RE: Operable Unit 2 Groundwater Technical Memorandum – Year 1
McLouth Steel Corporation Superfund Site – MID017422304 / A557
1491 West Jefferson Avenue, Trenton, Wayne County, Michigan

SUBJECT: The Michigan Department of Environment, Great Lakes, and Energy (EGLE) Comments on the Operable Unit (OU) 2 Groundwater Technical Memorandum Year 1; McLouth Steel Corp Site (Superfund Site).

SUBJECT: Comments to Operable Unit 2 Groundwater Technical Memorandum –
Year 1; McLouth Steel Corp. Superfund Site; Trenton, Michigan

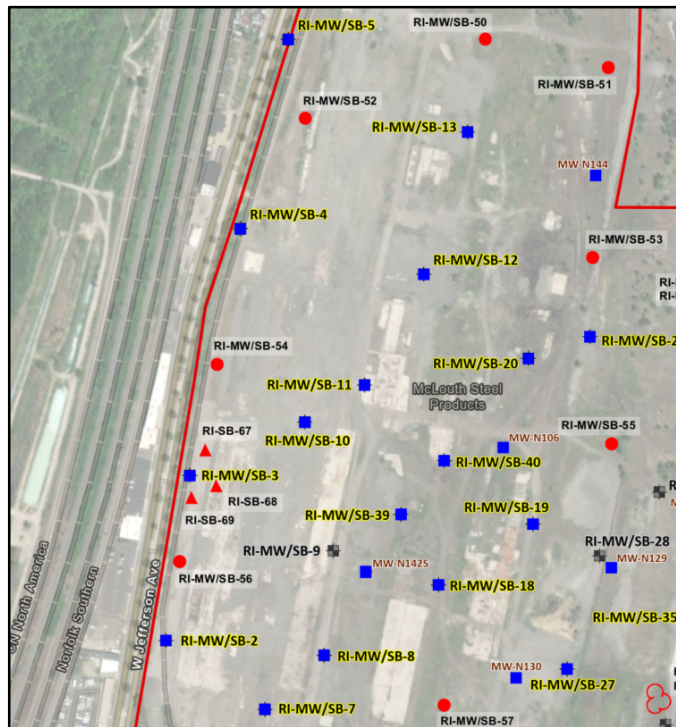
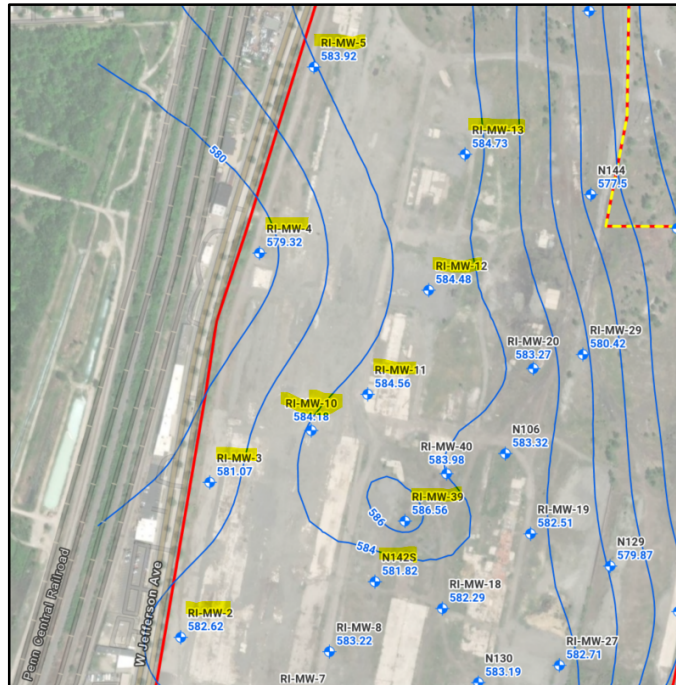
1. Page 4, Synoptic Water Level Measurement.
The text states "A groundwater divide is apparent, extending north–south through the middle of the site. The November 2023 synoptic round was collected on November 3, 2023, approximately 2 weeks after a rain event on October 20, 2023, that yielded 0.04 inches of rainfall. The presence of this groundwater flow divide may be a result of preferential or enhanced infiltration in the unpaved portions of the site. There may be potential influence of groundwater pumping or groundwater discharge at the former quarry west of West Jefferson Avenue. Additional synoptic water level rounds at dryer times of the year will be required to evaluate the persistence of the groundwater flow divide observed in the November 2023 data."

EGLE requests collecting water-levels from select monitoring wells (prior to installation of the following monitoring wells: RI-MW/SB-52, RI-MW/SB-54, RI-MW/SB-45) to confirm the presence or absence of the groundwater divide. EGLE's requested select wells for water-level measurement is presented as highlighted monitoring wells in the figures below:
